REMOVED BOTTOM NOTES IN TITLE BLOCK		Supplier's/Purchaser's No.	
By: <i>[Signature]</i> Date: 6-17-96		Customer's No. _____	
By: CLD Date: 2-26-96		Contract No. 953571	
By: M. L. TELLALIAN Date: _____		Dwg. ER601	
By: _____ Date: _____		Rev. 1	
By: _____ Date: _____		Sheet	
<p style="text-align: center;"><b>LIGO-D970054-01-B</b></p>

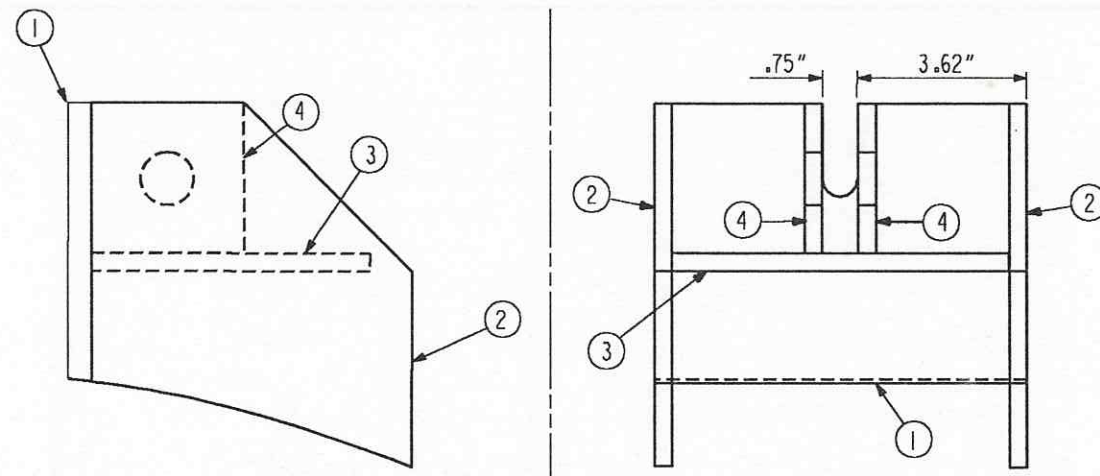
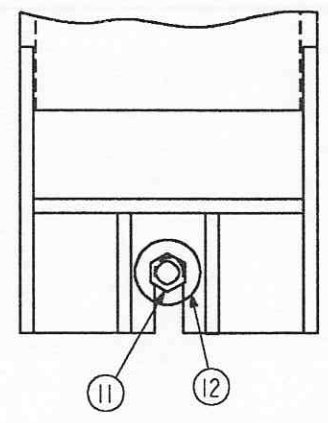
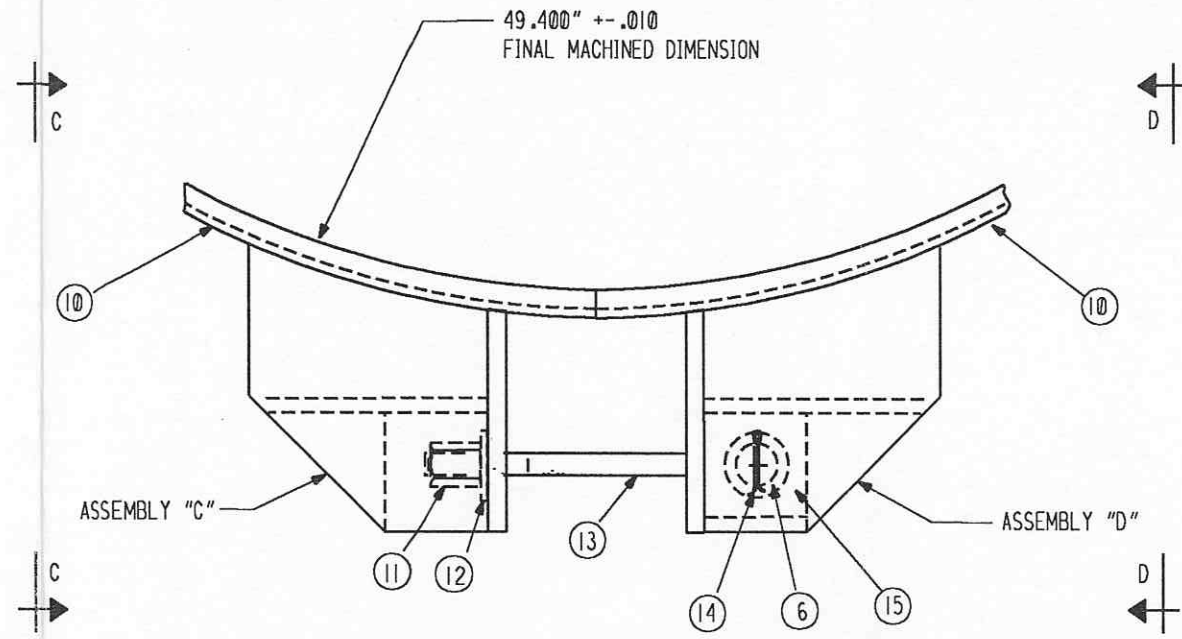
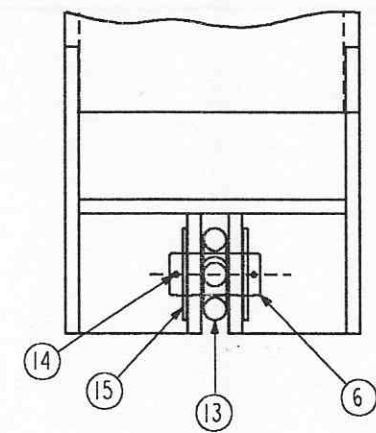
INDICATES CHANGE FROM PREVIOUS ISSUE
